REMARKS

Docket No. 1849012US1AP

Enclosures - Annotated Drawing Sheet 5
Replacement Sheet 5
Marked up drawing sheets 1 and 2

Fig 7a

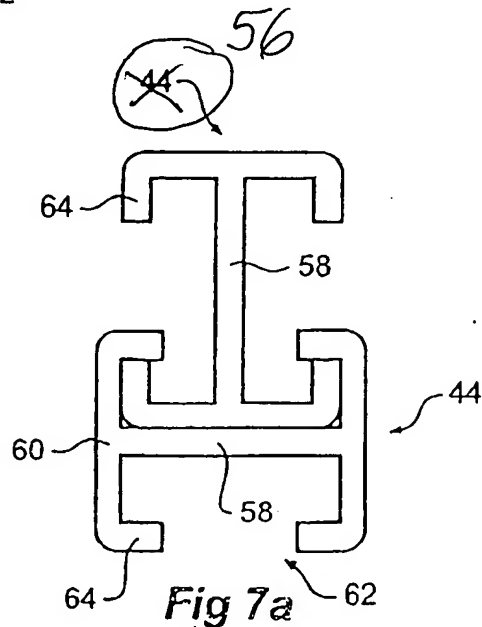
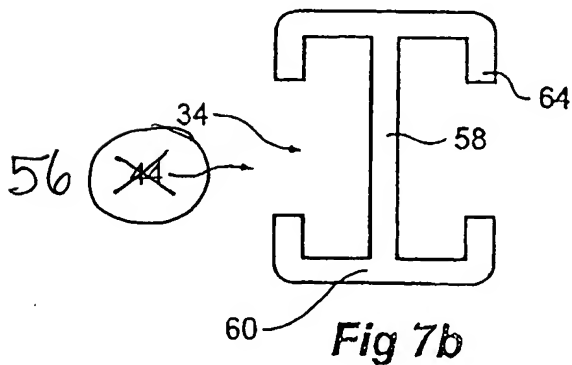
The Examiner objected to the drawings under 37 C.F.R. 1.83(a) because they fail to show elements 56 as described in the specification. In response, Applicant is providing a replacement sheet 5 in which the element "56" has been identified in Figs. 7a and 7b. Applicant is also providing a marked-up copy of sheet 5 to indicate the numbering change.
